From: Norman Hopkins [norman@amyhrf.org]
Sent: Monday, October 18, 2010 9:44 AM
To: Bruner, Douglas; Don Hambrick
Subject: Draft NUREG-1941
Attachments: NukeEIS Sept2010.pdf

Federal Register Notice: 75FR49539
Comment Number: 16

Comments of Norman Hopkins arising from the LNP DEIS review meeting on 23 September 2010

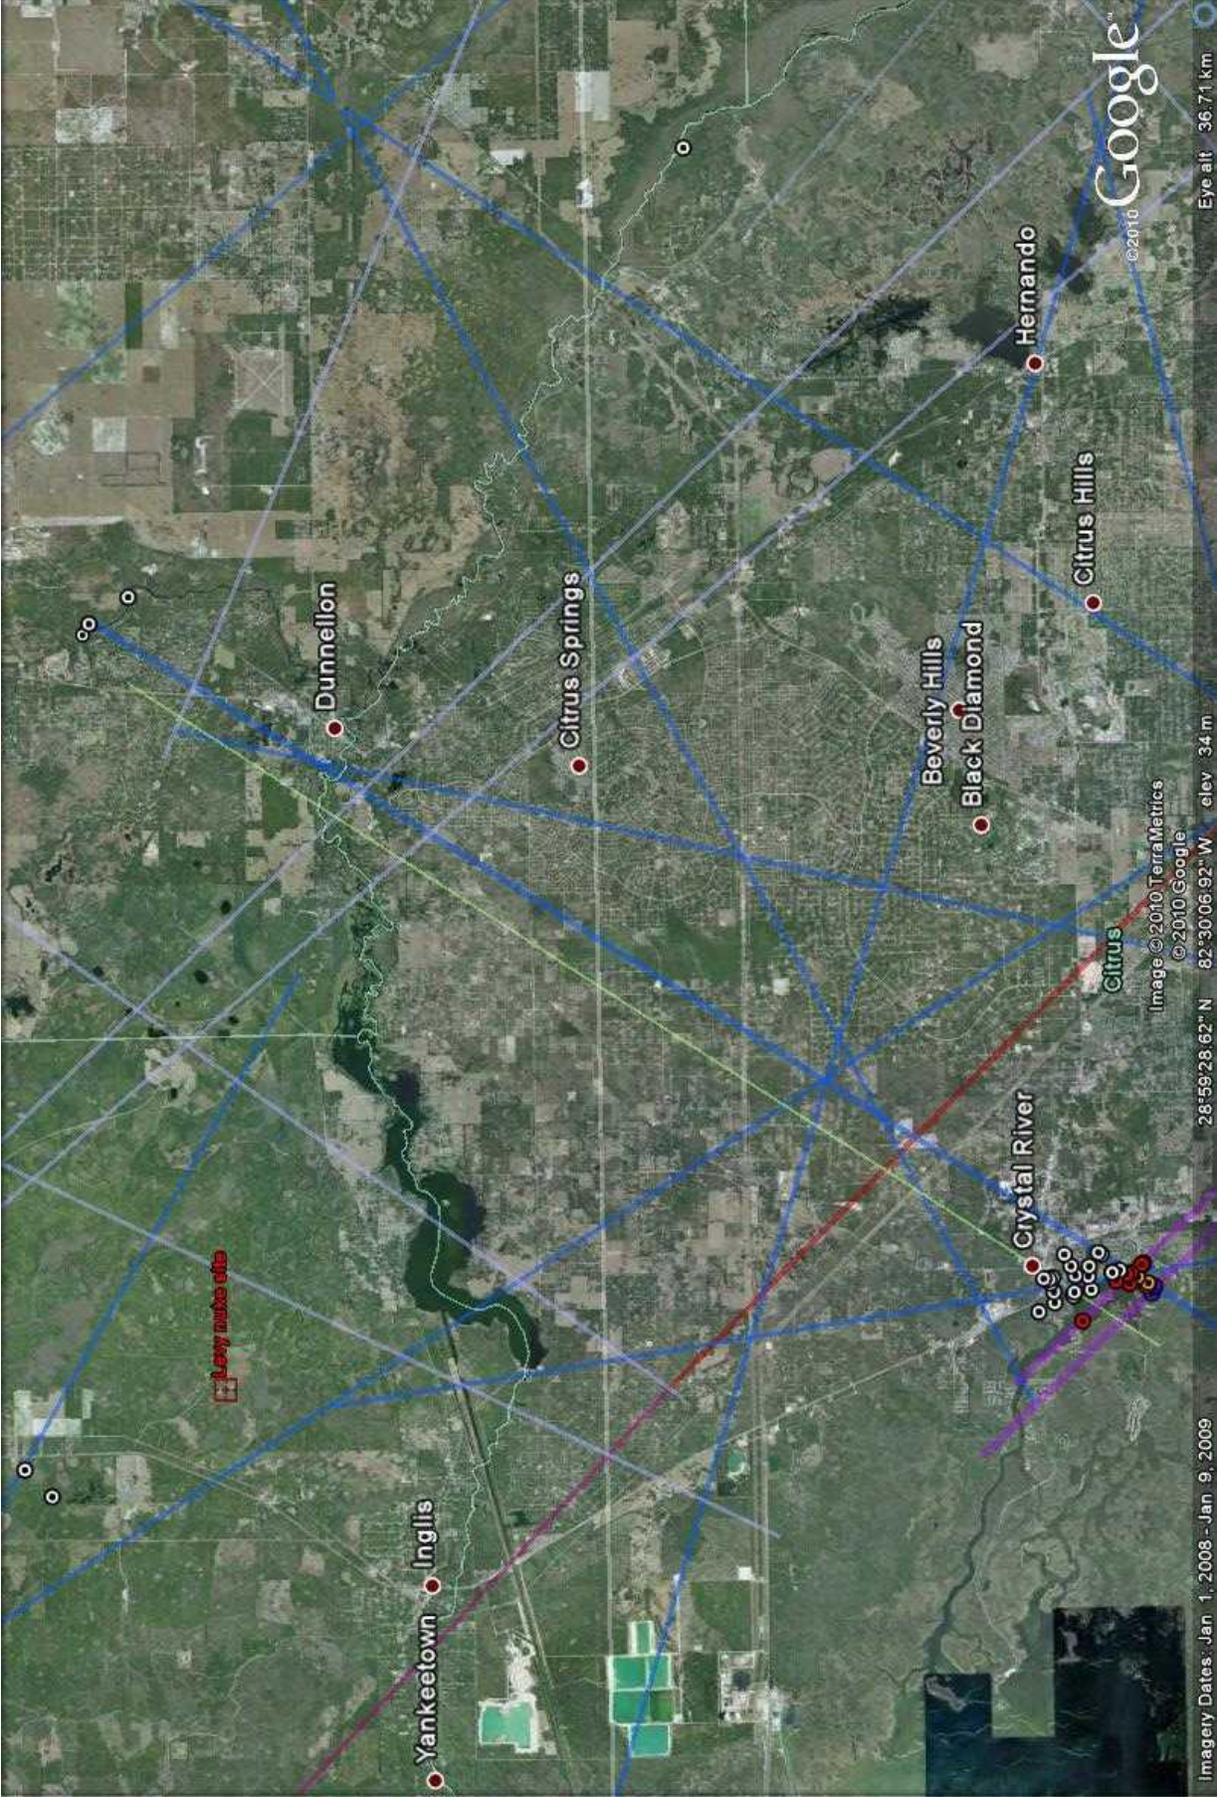
Page 2 -18, vol 1 of this DEIS, for example, shows run off from the LNP site westwards to the Gulf of Mexico. At best this is misleading as the unconfined aquifer system would not support such run off. Although aquifer flows across the site would be E to W, a fracture is indicated to the west of the site which would divert flows southward toward the Crystal River/ Kings Bay system and other Citrus County spring fed coastal river systems. All of which are omitted from the DEIS as Affected Environment. . (See attached Google Earth map overleaf. Note the south-trending blue lines into Citrus County from west of the LNP site).
